Access Compliance Report

Public Rights-of-Way

(Curb Ramps)

Intersection ID: 10028124	Main Street: HAWFIELD_WAY_DR	Cross Street: N/A	Location: NE
ADA ID: 2D0CEBCE4B83	Ramp Type: Perp	Initial Pass/Fail: Fail	Overall Compliance: No
Severity Score: 12.5			
Codes/Mitigation Info/Possible Solution		Field Measurements/Component Compliance

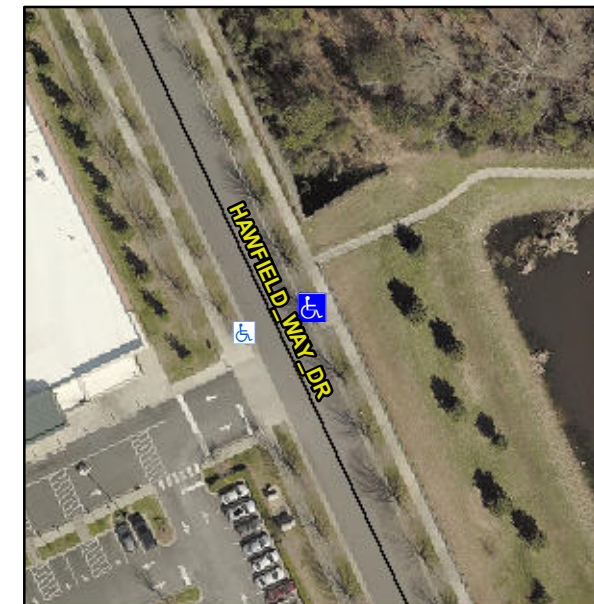
Possible Solutions:

Remove & Replace Entire Ramp.

PROW/ADA:

R304.2.2

Compliance	Description	Data	Compliance	Description	Data
N/A	Ramp Length (in)	95.0	No	Ramp Slope (%)	8.6
Yes	Ramp Width (in)	48.0	Yes	Ramp XSlope (%)	1.9
N/A	Flare Type LT	N/A	N/A	Flare Type RT	N/A
N/A	Flare Slope LT (%)	N/A	N/A	Flare Slope RT (%)	N/A
N/A	Flare Traversable LT?	N/A	N/A	Flare Traversable RT?	N/A
N/A	Landing Length (in)	N/A	N/A	DWS Provided?	N/A
N/A	Landing Width (in)	N/A	N/A	DWS Contrast?	N/A
N/A	Landing Slope (%)	N/A	N/A	DWS Length (in)	N/A
N/A	Landing X Slope (%)	N/A	N/A	DWS Full Width?	N/A
N/A	Landing Curb? (Y/N)	N/A	N/A	DWS Offset (in)	N/A
N/A	Shared Landing?	N/A			
N/A	Gutter Ponding?	N/A	N/A	Gutter Slope (%)	N/A
N/A	Gutter Lip Ht (in)	N/A	N/A	Gutter X Slope (%)	N/A
N/A	Painted X Walk1?	No	N/A	Painted X Walk2?	N/A
	X Walk 1 Direction	To SW		X Walk 2 Direction	N/A
N/A	X Walk 1 Width (in)	N/A	N/A	X Walk 2 Width (in)	N/A
	X Walk 1 Slope (%)	2.1		X Walk 2 Slope (%)	N/A
	X Walk 1 X Slope (%)	2.0		X Walk 2 X Slope (%)	N/A
